FMVSS Noncompliance
Recall Campaign2022MY
Telluride (ON)

SC237

INSTRUMENT CLUSTER ASSEMBLY
REPLACEMENT (SC237)

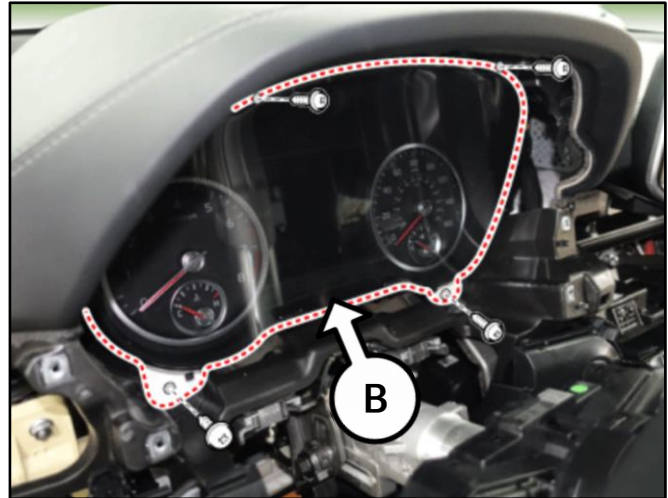
1. Note the original vehicle mileage (A) before removing the instrument cluster.

2. Replace the instrument cluster (B) by referring to "Body Electrical System → Indicators and Gauges → Instrument Cluster → Repair procedures" in the applicable Shop Manual on KGIS.
